DA2024/0330 / PPSSCC-591 - 1 Tamplin Road, GUILDFORD NSW 2161
Attachment 9 - Cumberland Local Environmental Plan 2021 Compliance Table

| Clause | Requirement | Comments | Compliance |
|--|--|--|------------|
| |  <p>Figure 1 - Roof Plan and Building Heights</p> | | |

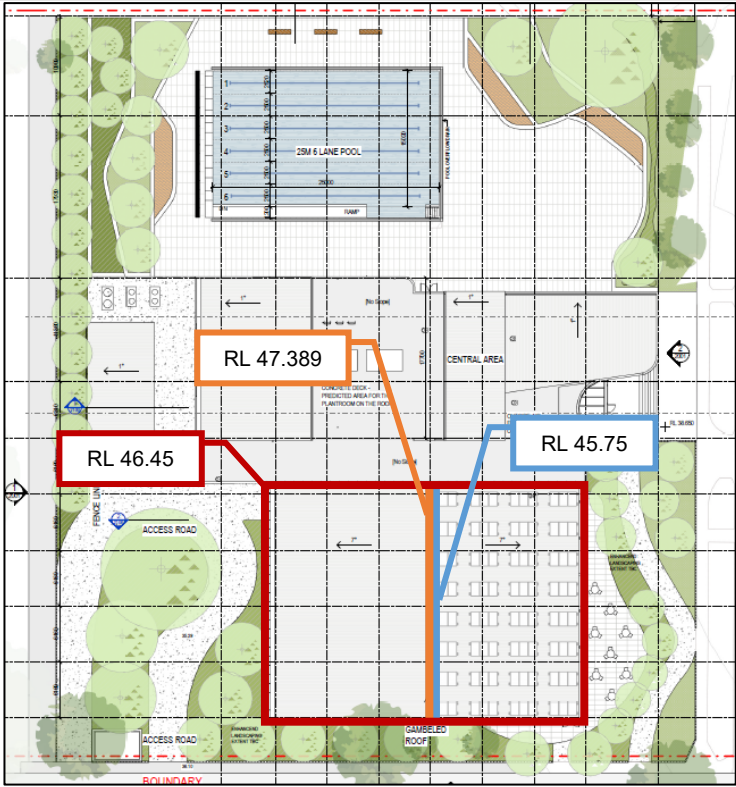
| Clause | Requirement | Comments | Compliance |
|--|---|---|------------|
| 4.3 Height of Buildings | (2) The height of a building on any land is not to exceed the maximum height shown for the land on the Height of Buildings Map. | No maximum height is prescribed for the site. A maximum building height of RL 47.45 metres is proposed to the top of the solar panels on the rooftop (marked blue below), RL 47.389 metres to the ridge of the main roof over the indoor pool building (marked orange below) and RL 46.45 metres to the top of the surrounding building parapet walls (marked red below). These levels result in a maximum building height of 11.08 metres to the top of the solar panels, 11.04 metres to the roof | N/A |

| Clause | Requirement | Comments | Compliance |
|--|--|--|------------|
| | | ridgeline and 10.35 metres at the lowest point of the site to the top of the surrounding building parapet walls. The heights are based on the existing natural ground levels closest to the proposed building depicted on the Survey Plan accompanying the DA. | |
